Meeting Minutes of the **Manjimup Rea Park & Collier Street (MRCR) Advisory Committee** meeting held at the JC Rose Room, Council Chambers, 37-39 Rose Street, Manjimup on **Tuesday 23 May 2023,** commencing at **5.30pm.**

Concept Design Development for New Collier Street Pavilion and Storage Units – E. Apeldoorn / Sam Brown, H & H Architects

MANJIMUP RECREATION PAVILION

Concept Design Report – Pros & Cons

PROPOSED SITE PLAN

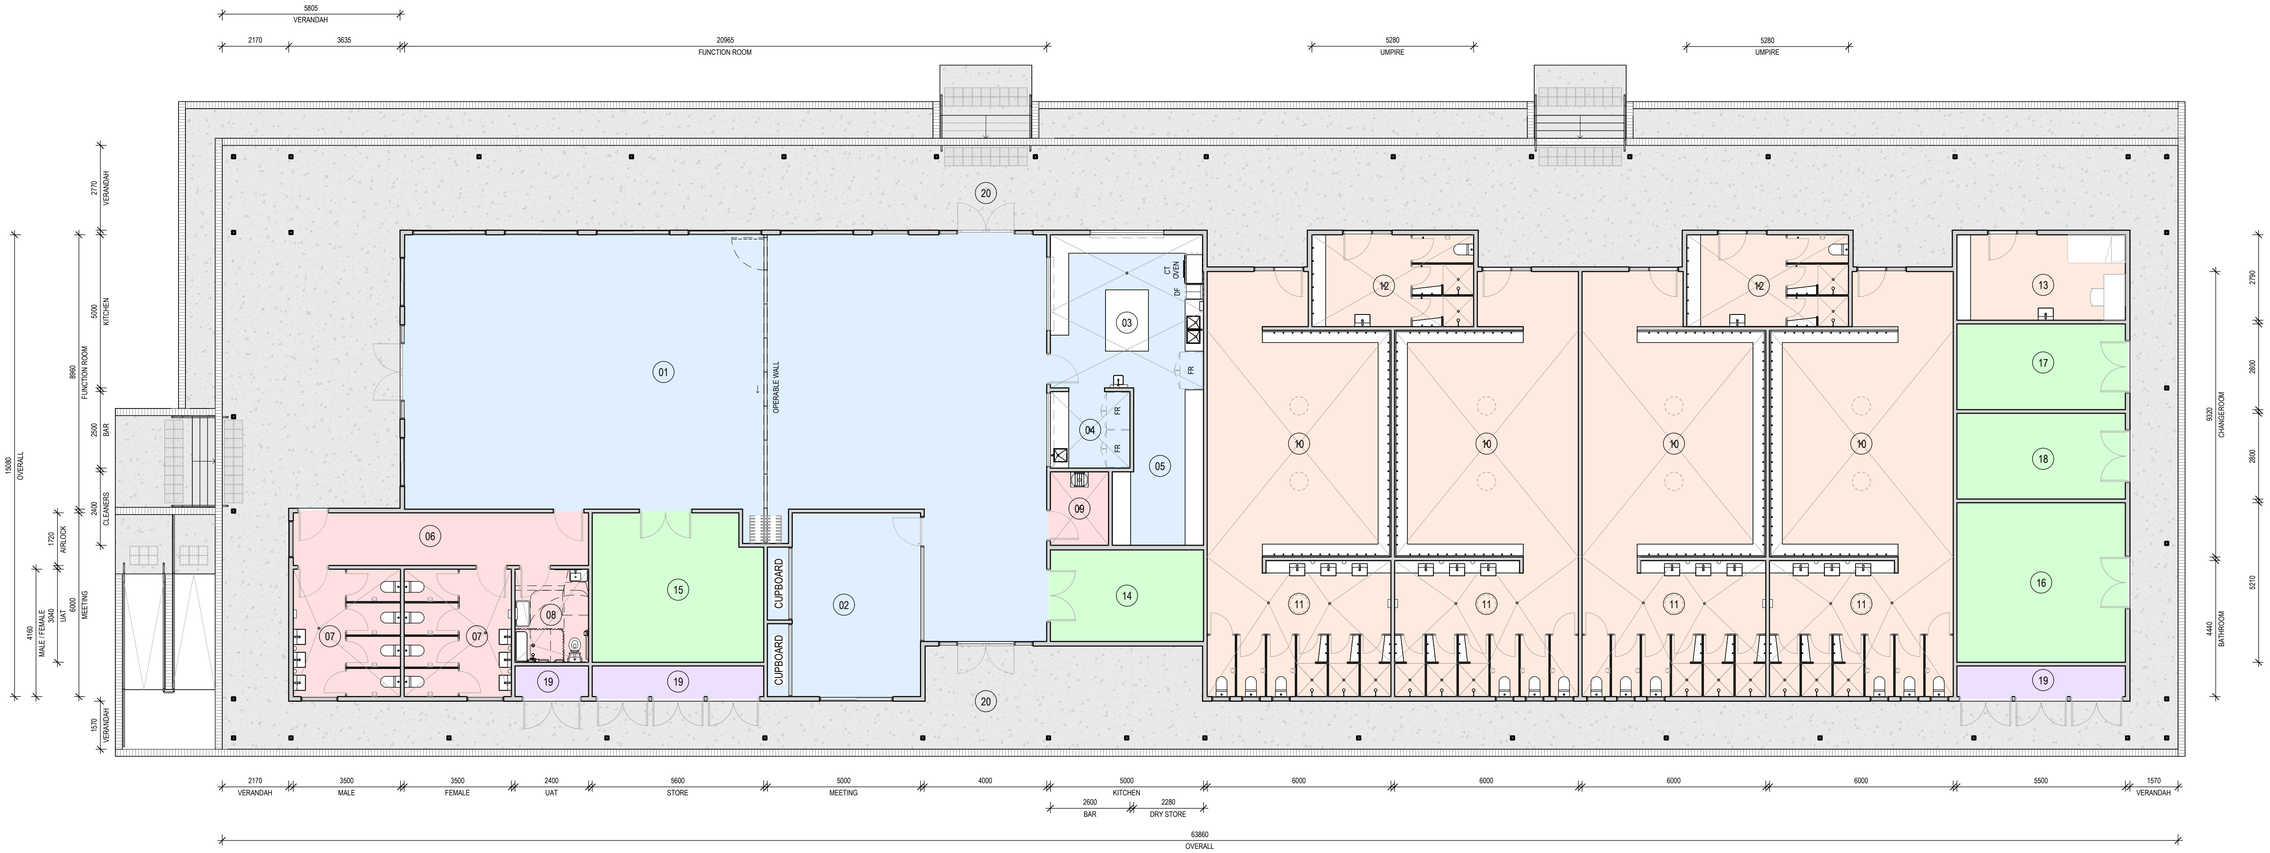
- Comments/questions on the concept location:
  - Viewing for southern field from pavilion questioned. Provision of car viewing and coverage at front of storage facility provides sheltered viewing for the southern field.

- Query about parking directly near the pavilion.
  - Questioned the number of parking spaces for a function space of that size. E. Apeldoorn explained that the minimum requirements have been met.

OPTION 02 FLOOR PLAN

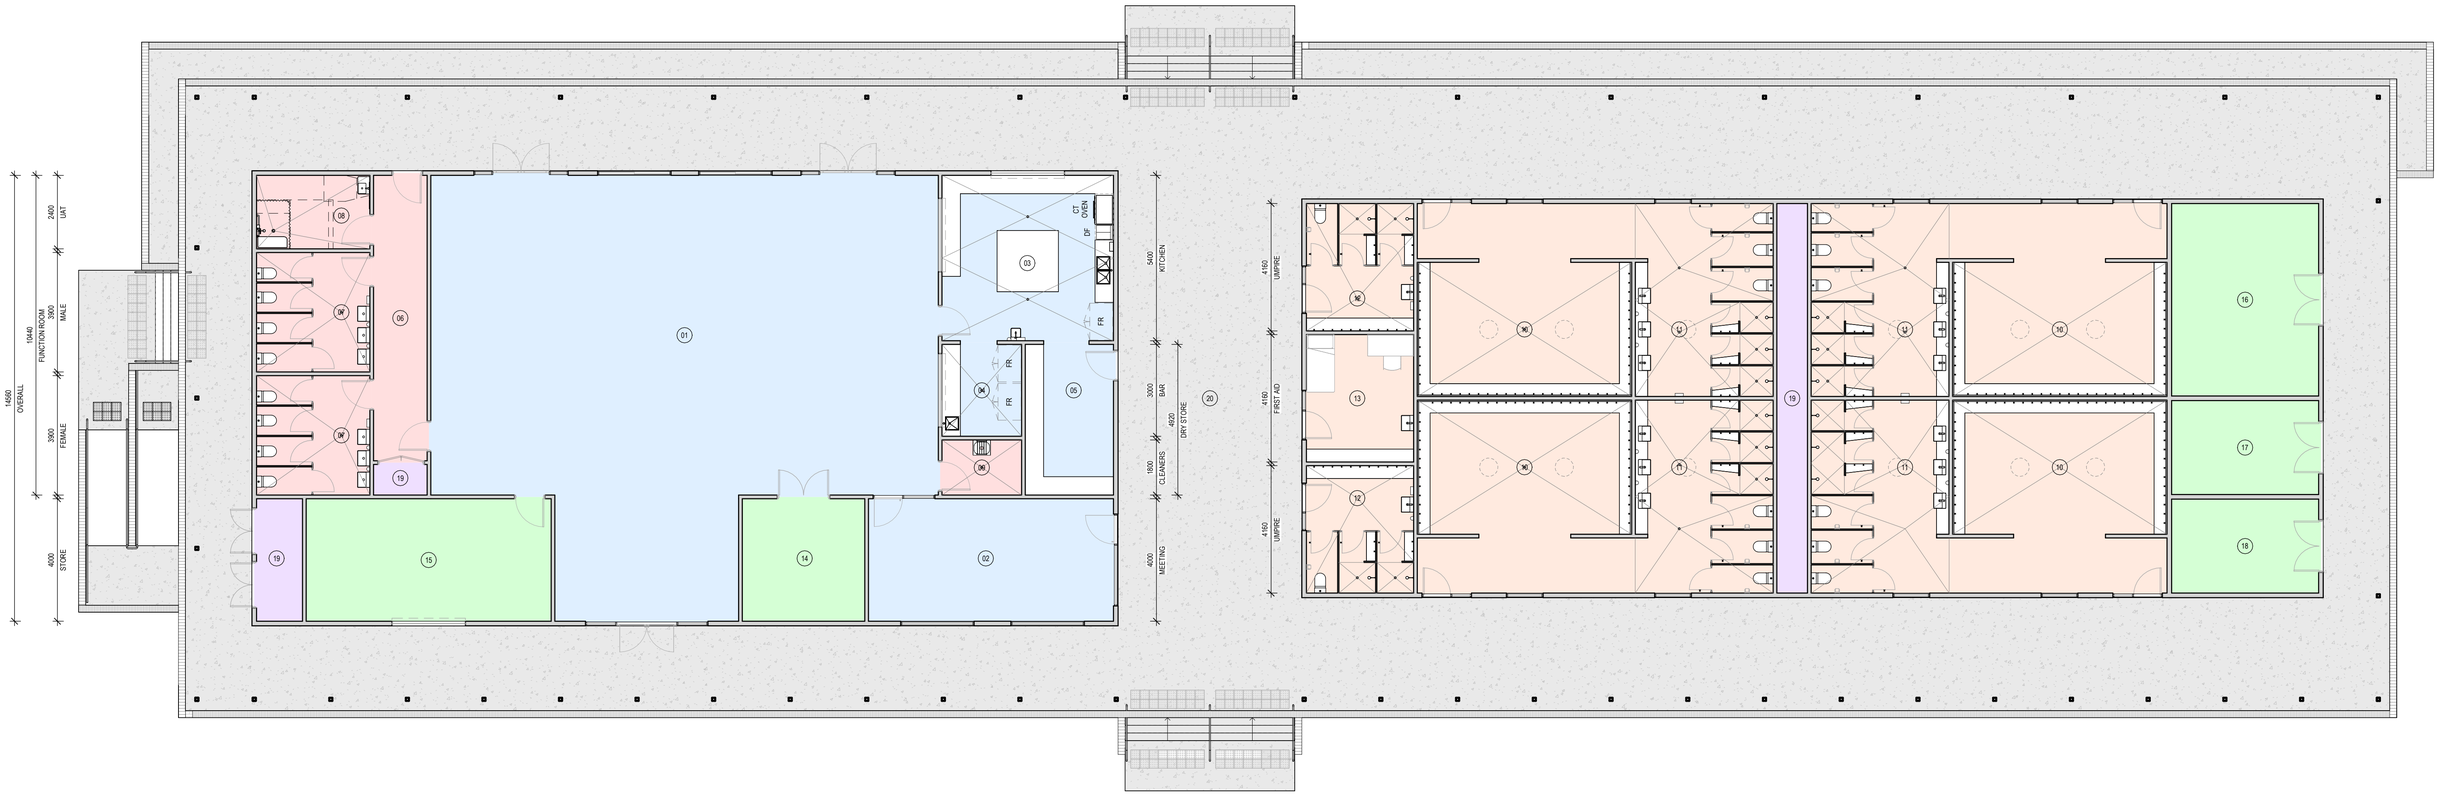
- Security concerns (both theft and child safety) were raised with access to some change rooms being on the west side of the building.
  - Alignment of the buildings could be changed to help with providing a wind barrier from the southerly winds. Concerns about a breezeway causing a wind tunnel.

- The Unenclosed Covered Area is 218m^2 greater than Option 1, mainly due to the elongated verandah and covered link between the two buildings which adds cost.
- Fire rated doors and particularly fire rated windows are significantly more expensive than standard commercial doors and windows.
- Only two of the changerooms are accessed from the oval side of the facility, with the other two accessed from the rear.
- There is no operable wall in Option 2 which does not allow the Function Room to be divided, it may be possible to incorporate an operable wall into the design, but it would require some manipulation of the floor plan to create two relatively even spaces.
- The location of the toilets block the view from the Function Room to the north.

OPTION 03 FLOOR PLAN

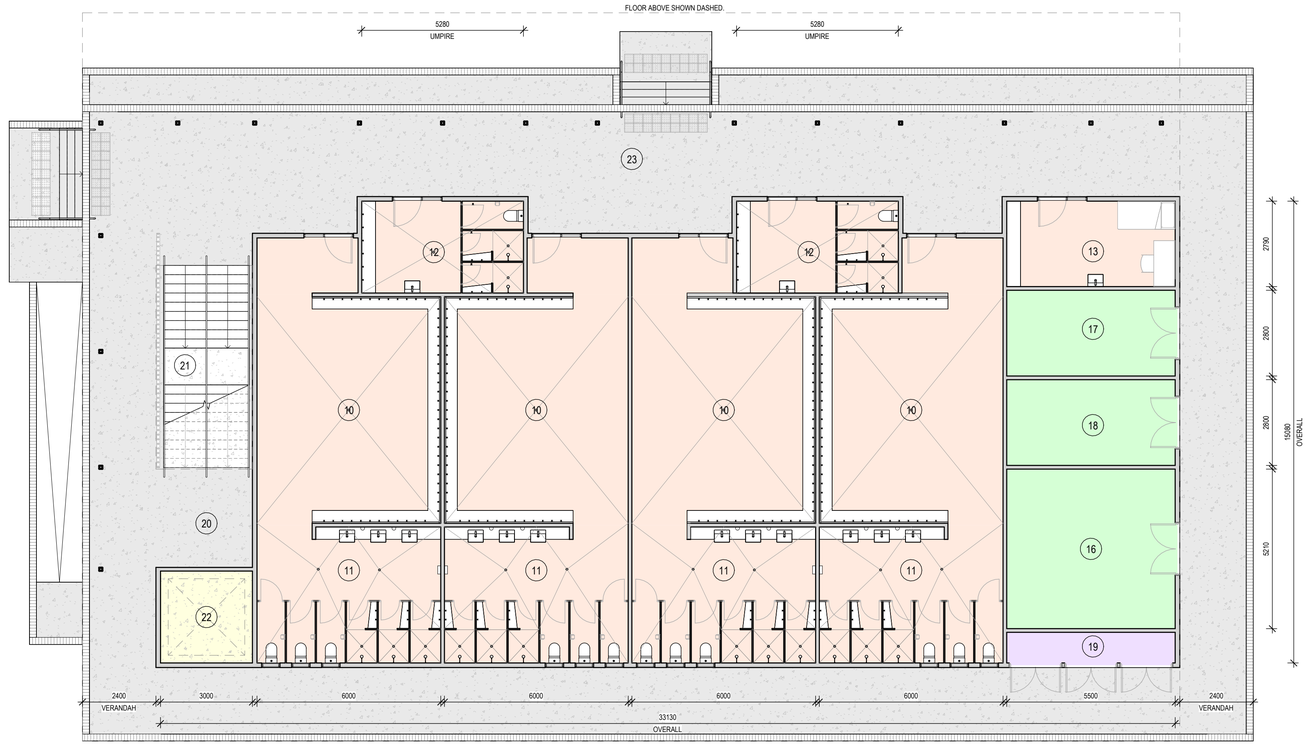
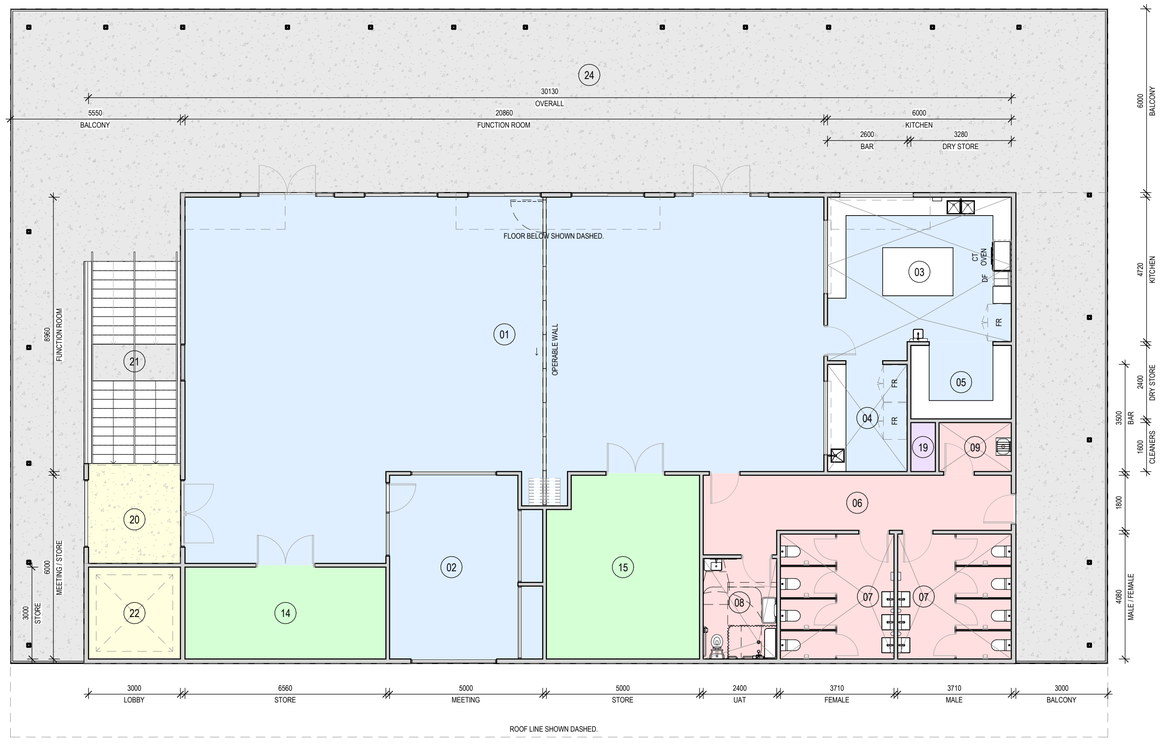
○ Suggestion to build up Pavilion area higher to add another layer of seating rather than the double storey option (more expensive to build and to maintain) ○ Remove the meeting room as the function space can be used for this purpose. ○ Remove 1 of the 2 umpire rooms. ○ Separation of the two sections (pavilion v change rooms) is desired to reduce fire protection costs if building size over 500m2. Alternatively 500m^2 in one building may be achievable if some rooms are reduced/removed. • Process going forward: ○ Clubs to be provided with concept design specifications and sporting guidelines for provision of feedback. **Action: Clubs to provide feedback by Monday 12 June (2 weeks time from receiving the concept designs).** ○ Input to be sought from karate. **Action: Shire to contact karate for comment.** ○ Calculate floor space of Collier Street pavilion hall area for the sake of comparison. **Action: Shire to measure hall space and share with clubs.**

- The floor area of the building is over 500sqm and therefore fire hydrant coverage will be required. The water pressure at the site is not sufficient for fire hydrants and therefore water tanks and pumps will be required to increase the water pressure to meet DFES water pressure and flow requirements.

- To provide compliant universal access a lift will be required for the building. A lift is an expensive item and requires ongoing maintenance which is generally serviced from Perth.

- The Fully Enclosed Covered Area is the largest of the three options, 36m^2 larger than Option 1 and 44m^2 larger than Option 2.
- The Function Room, Kitchen and Meeting Rooms are located on the first floor which makes accessibility for deliveries and building users in general more difficult than a ground floor location.

- Two storey construction is generally more expensive due to the construction methodology and access requirements for working at heights.
- The ongoing maintenance costs are generally higher for a two storey building as access equipment is required to access high level components of the building, i.e. for window cleaning, maintenance to roof mounted equipment etc
